NEWMAR CORPORATION WARRANTY DEPARTMENT

<input type="checkbox"/> Chassis Components					<input type="checkbox"/> Plumbing & Bath Components				
<input type="checkbox"/> Construction Components					<input type="checkbox"/> Windows, Awnings, Vents, & Doors				
DESCRIPTION OF PROBLEM									
Adding 15 amp fuse to Suburban SF 42 & SF 42F.									
RECOMMENDED SOLUTION									
Suburban has added 15-amp fuse to add to the protection for overload. Refer to Suburban Service Bulletin, which is attached, for fuse location.

Motor Assembly-Fuse
Models Affected-SF-42
and SF-42F Furnaces

TSI: RV94-357

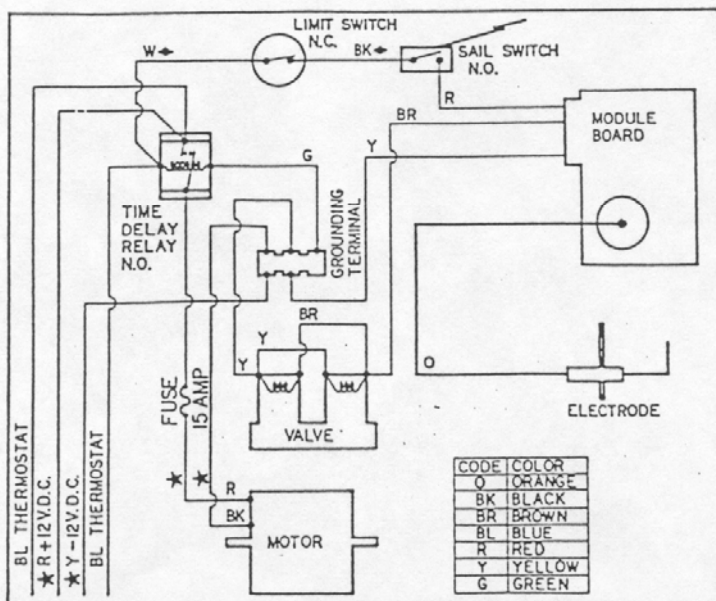
Effective immediately, motors on furnace models SF-42 and SF-42F beginning on serial number 940101886 are protected by an external (15) amp fuse in the positive leg of the motor circuit. This fuse provides overload protection and is an alternative to the built-in internal overload supplied with all other Suburban furnace motors. This change is limited to the "42" model due to a new motor supplier. The wiring diagram below shows the fuse and location. Please contact the factory Service Department if you have any questions, phone 615-775-2131.
